SERVICE BULLETIN

SERVICE BULLETIN NO: 28-006

FUEL - DISTRIBUTION FUEL BOOSTER PUMP - DAMAGE TO WIRES DURING INSTALLATION

PILATUS
PC-7 MK II
SERVICE BULLETIN

Lead Protection - Installation
Figure 1

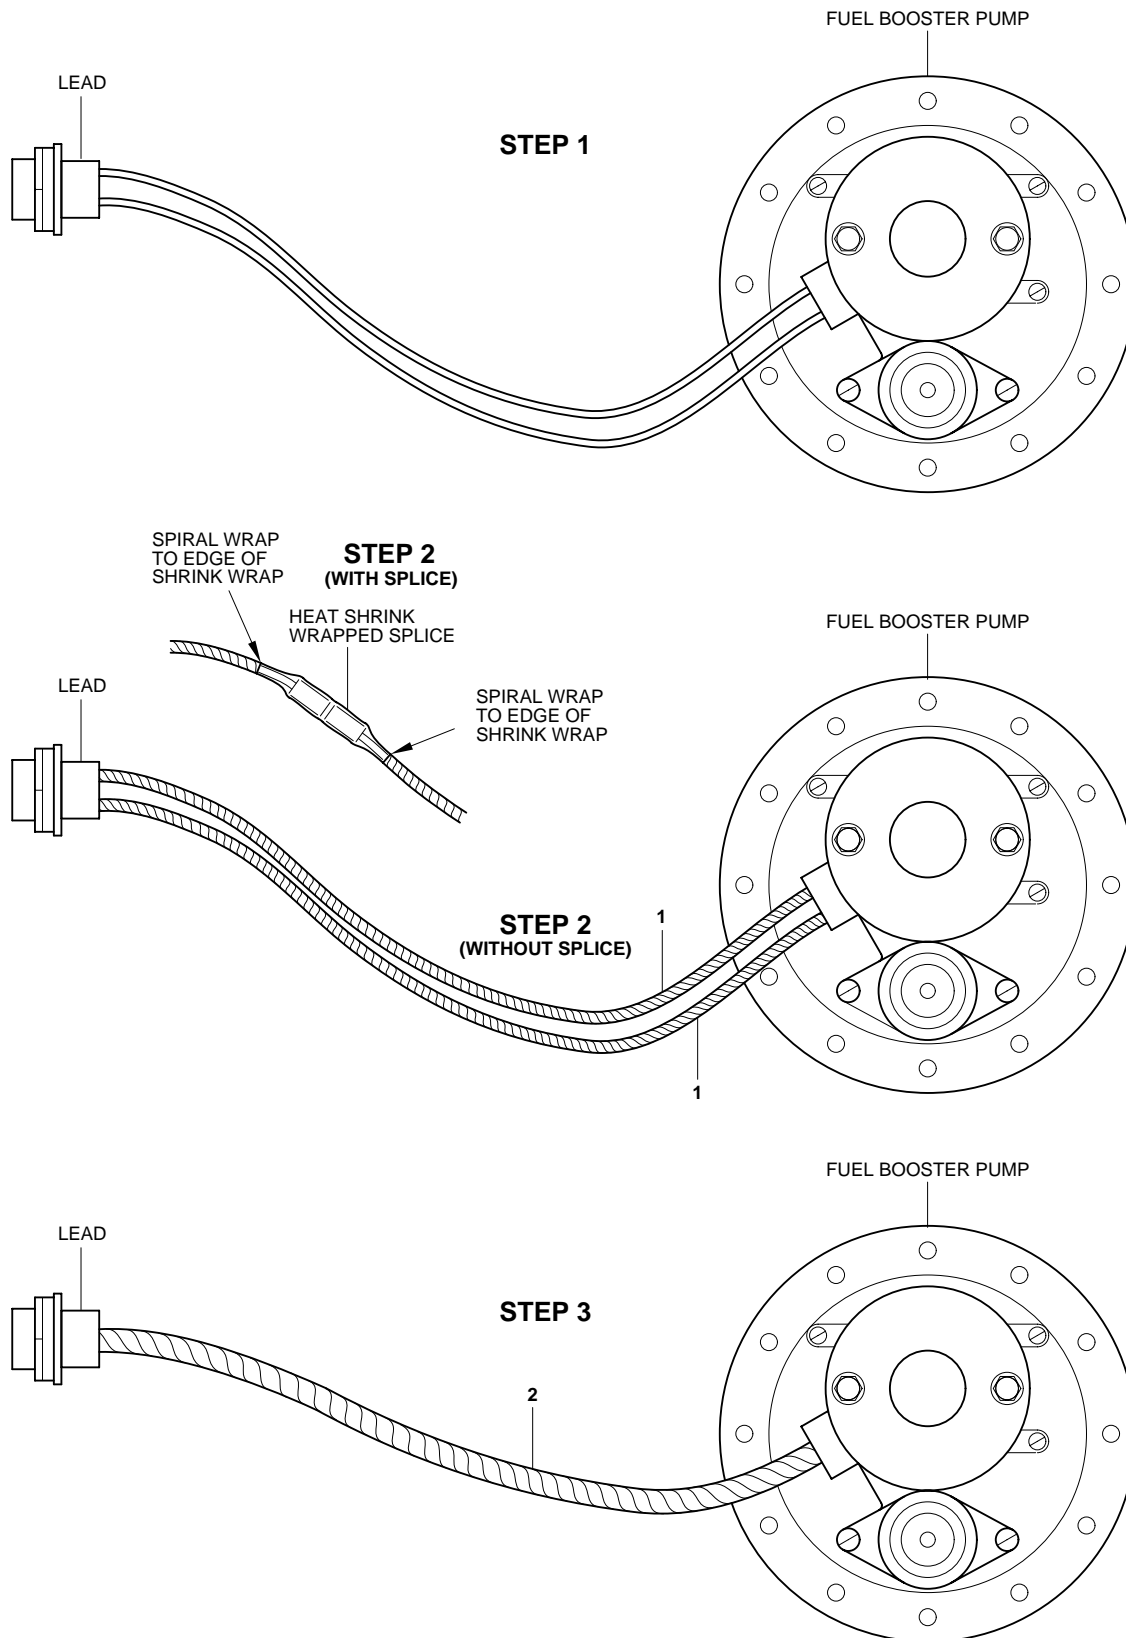
C. Installation of the Lead Protection (Ref. Fig. 1)

- (2) Install the spiral wrap on each wire:
 - (a) For a wire with no splice. Wind spiral wrap (1) around the full length of the wire. Twist the spiral wrap (1) to make sure there are no gaps and cut the spiral wrap (1).
 - (b) For a wire with a splice. Wind spiral wrap (1) around the wire between the edge of the shrink wrap and the end of the wire. Twist the spiral wrap (1) to make sure there are no gaps and cut the spiral wrap (1). Do this for each side of the splice.
- (3) Release the black wire and the white wire.
- (4) Wind the spiral wrap (2) around the full length of the black wire and the white wire. Twist the spiral wrap (2) to make sure there are no gaps and cut the spiral wrap (2).

- (3) Install the spiral wrap on each wire:
- (a) For a wire with no splice. Wind spiral wrap (1) around the full length of the wire. Twist the spiral wrap (1) to make sure there are no gaps and cut the spiral wrap (1).
- (b) For a wire with a splice. Wind spiral wrap (1) around the wire between the edge of the shrink wrap and the end of the wire. Twist the spiral wrap (1) to make sure there are no gaps and cut the spiral wrap (1). Do this for each side of the splice.
- (4) Release the black wire and the white wire.
- (5) Wind the spiral wrap (2) around the full length of the black wire and the white wire. Twist the spiral wrap (2) to make sure there are no gaps and cut the spiral wrap (2).
